HILL EAST PARCELS B1 + B2

WASHINGTON, DC
GTM ARCHITECTS DC PROJECT #21.0515

ZONING COMMISSION
District of Columbia
CASE NO. 24-008
EXHIBIT NO. 2A3

PARKING LEVEL 1 | A1.02

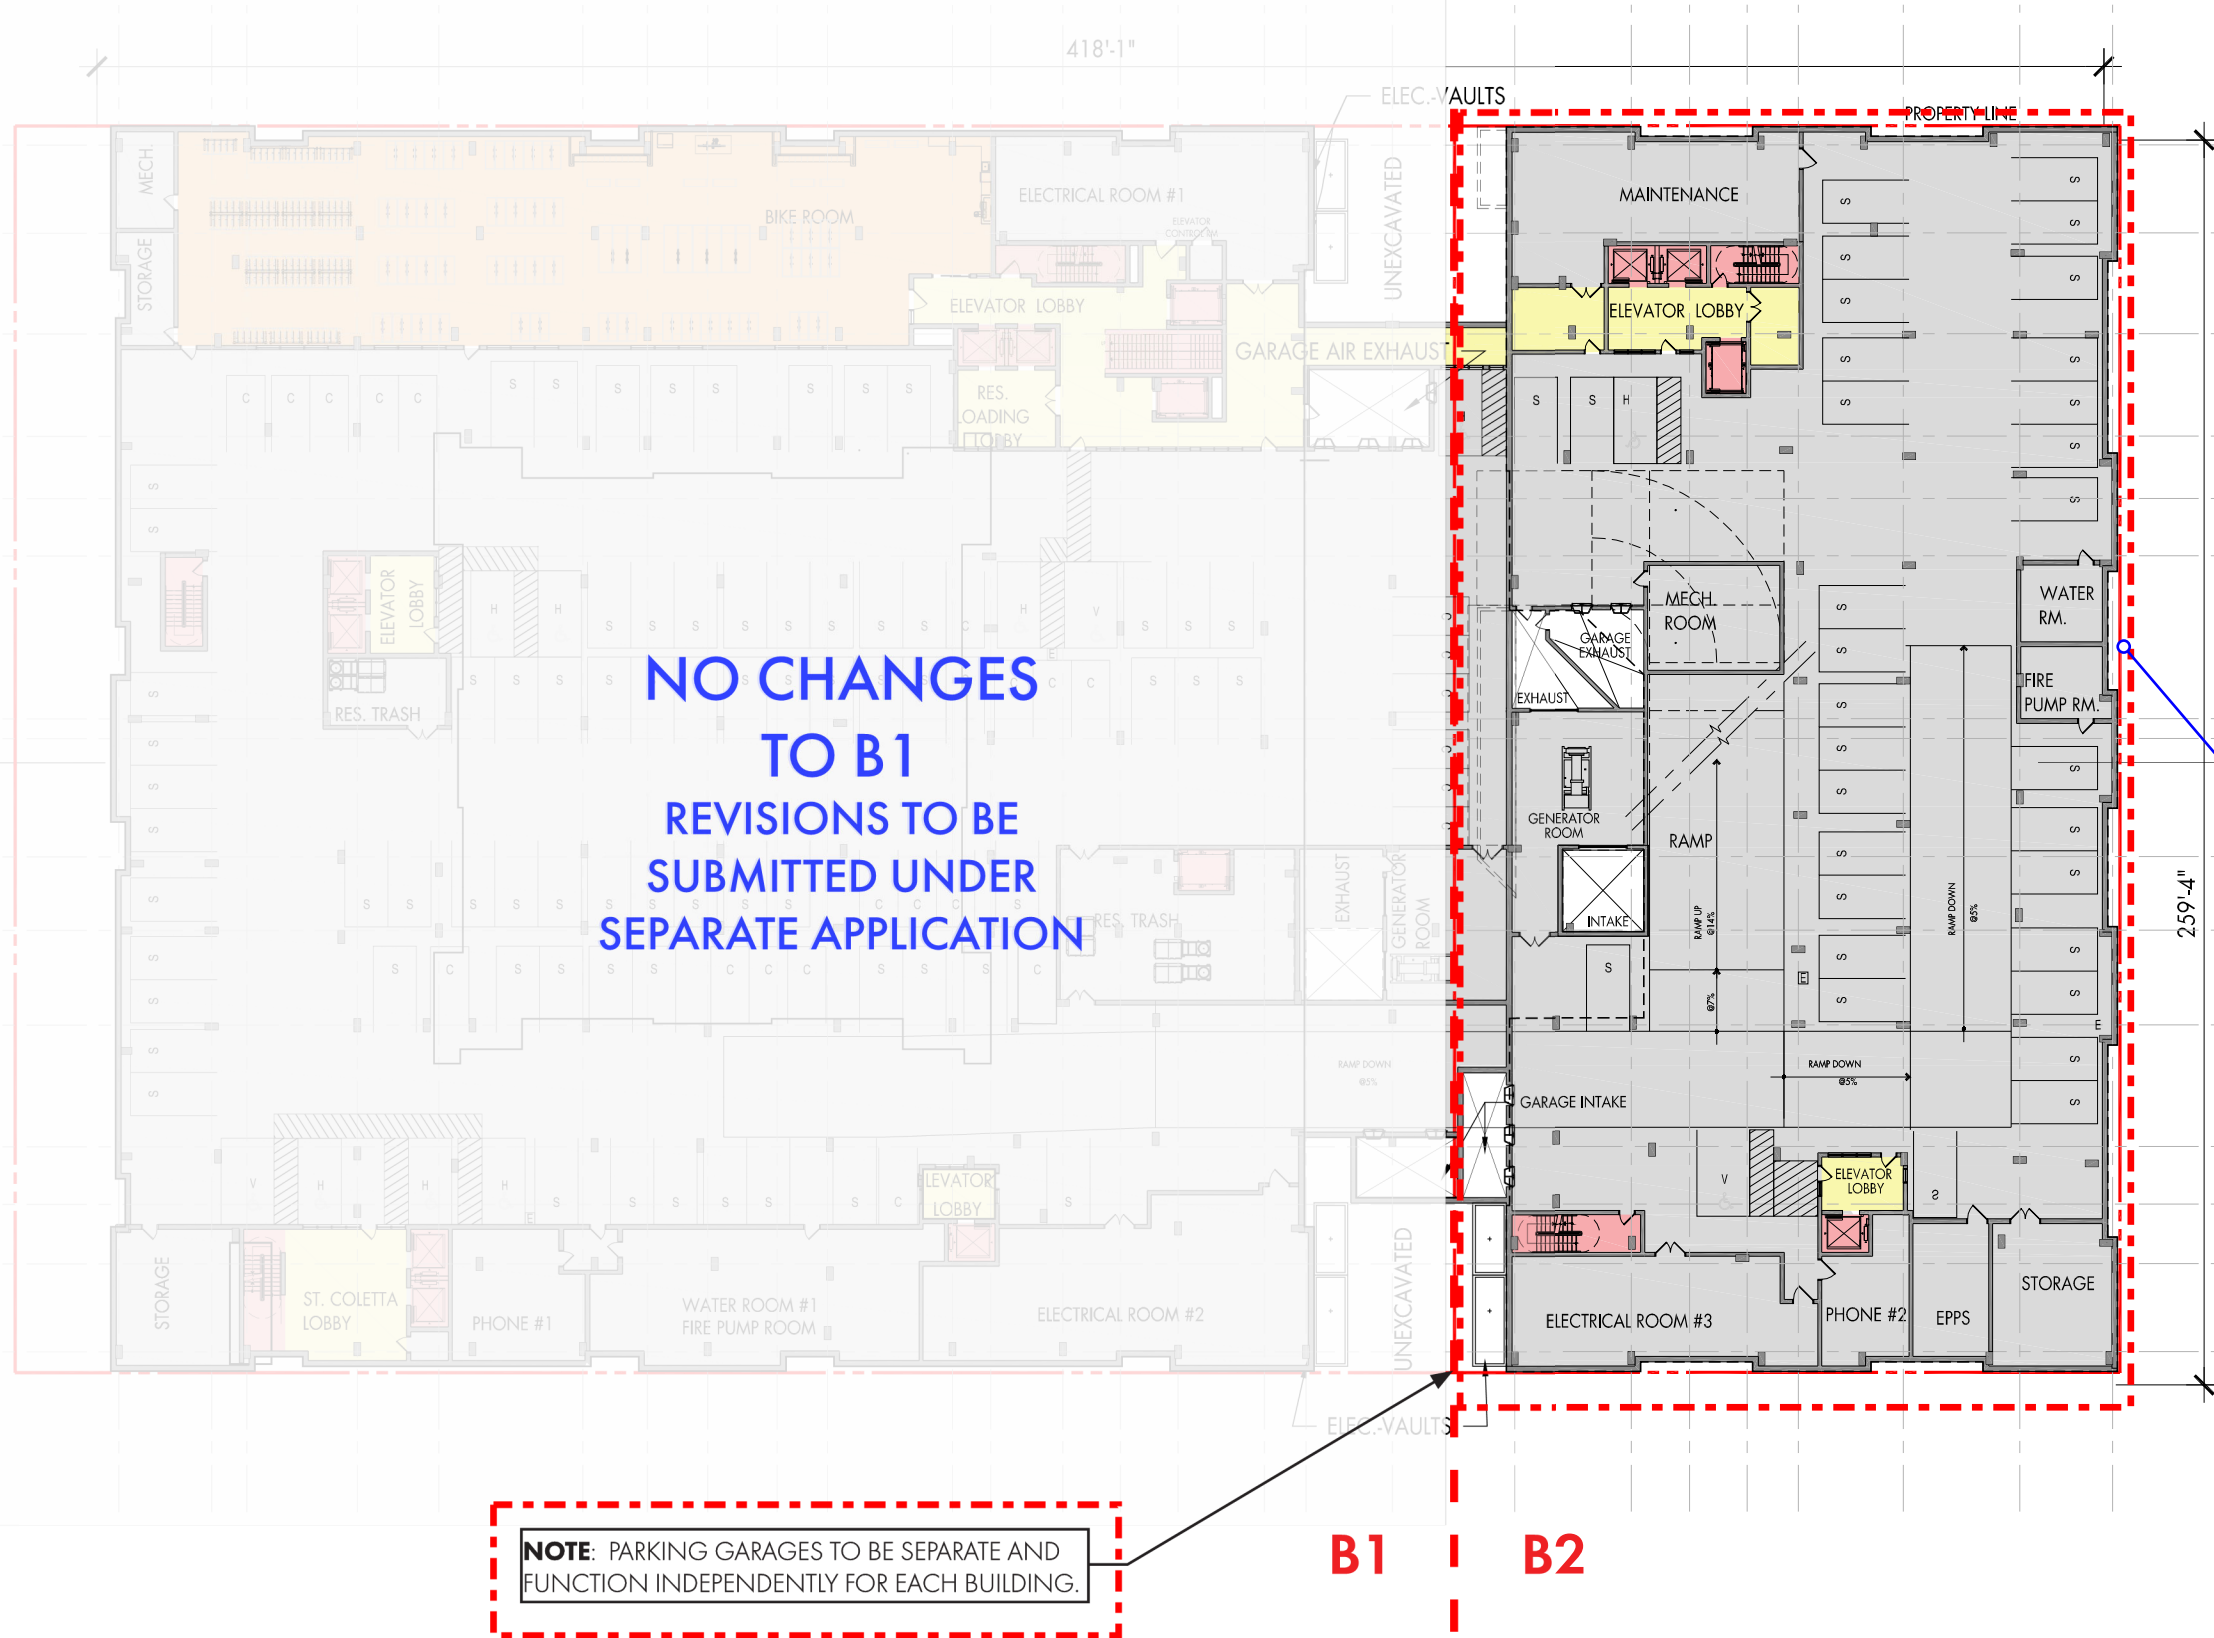
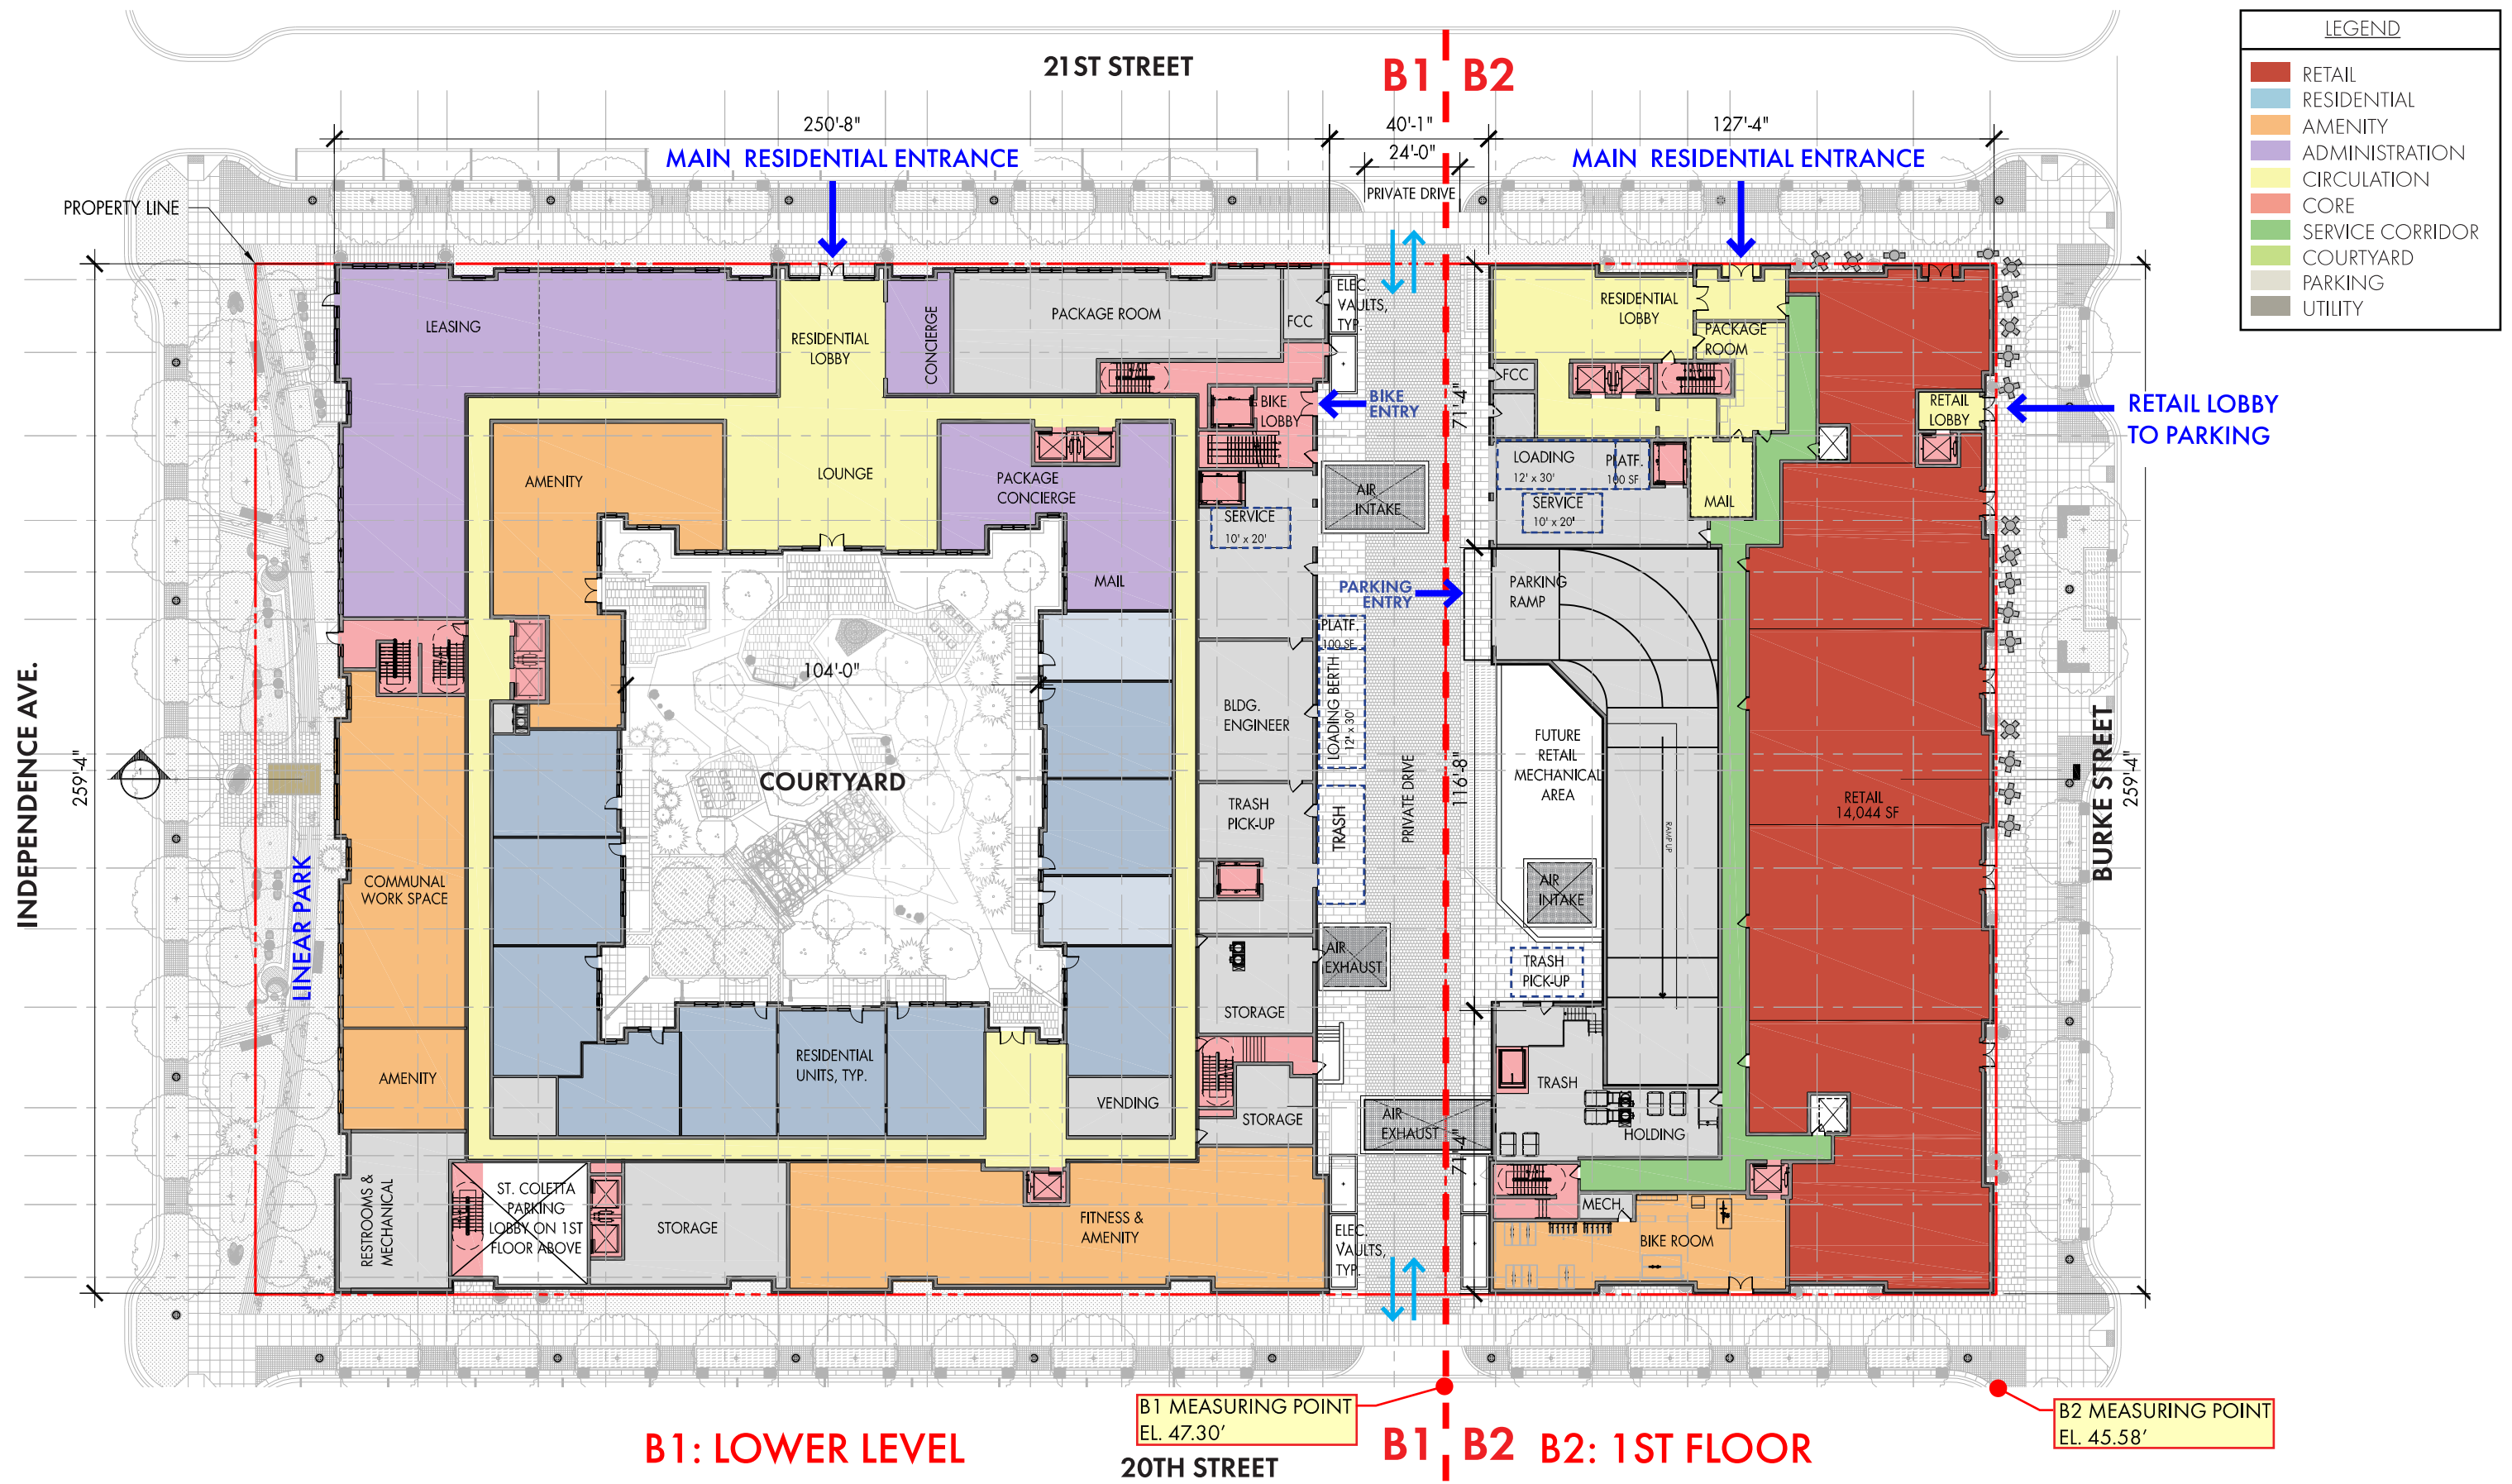
AREA OF MODIFICATION

NOTE:
VEHICLE AND BIKE PARKING REDUCED IN
BUILDING B2 DUE TO DELETION OF RETAIL AND
REDUCED UNIT COUNT.
